Product Change Notification

PCN26-45 Changes to select items from QHPS Series of Linear DIP Switches

This document announces changes impacting select items from QHPS series of Linear DIP Switches.

ii. Product appearance:

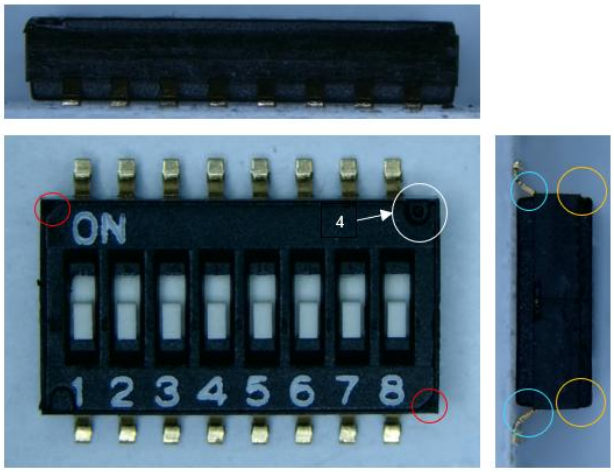
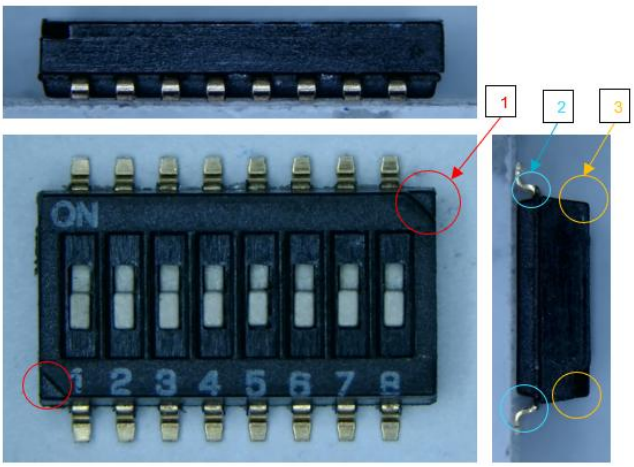
Difference points: 1. Chamfering position
2. Terminal bending
3. Cover shape
4. Surface gate

iii. Dimensional specifications

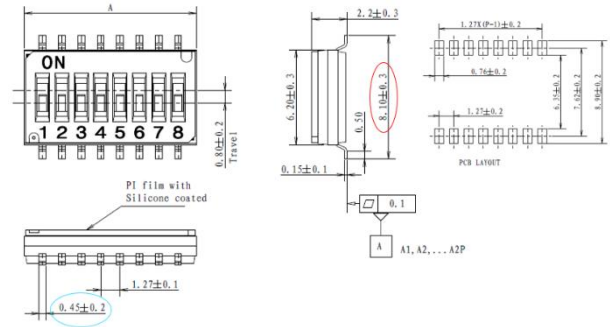
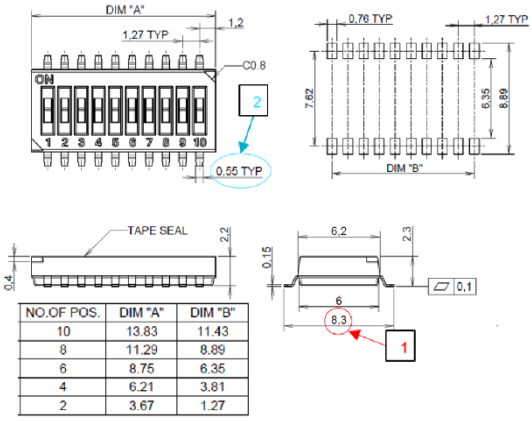
Difference points: 1. Terminal span dimension (Nominal) – measured product size is 8.2mm; it is the same.
2. Terminal width
